Product / Process Change Notification (PCN) ☐ Major change ☐ Minor change		
PCN #:	PCN_FeSTAR-CLIP_20210527	Change Category:
Affected Series:	WE-STAR-CLIP; 7427711, 7427713	 □ Equipment / Location ☑ General Data □ Material □ Process
PCN Date:	April 27, 2021	☐ Product Design
Effective Date:	May 27, 2021	☐ Shipping / Packaging☐ Supplier☐ Software
Contact:	Product Management	Data Sheet Change:
Phone:	+49 (0) 7942 - 945 5001	⊠ Yes □ No
Fax:	+49 (0) 7942 - 945 5179	Attachment:
E-Mail:	pcn.eisos@we-online.com	□ Yes ⊠ No

DESCRIPTION AND PURPOSE OF CHANGE:

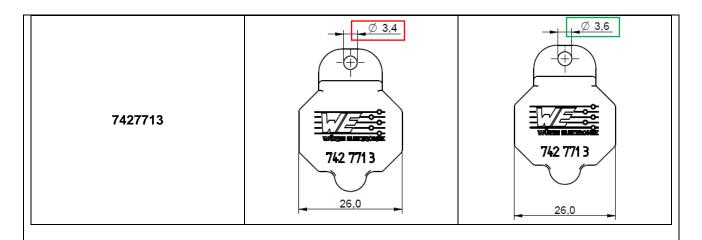
Because of a database mismatch, Würth Elektronik will correct mechanical dimensions of the boreholes.

The borehole diameter will be corrected as follows:
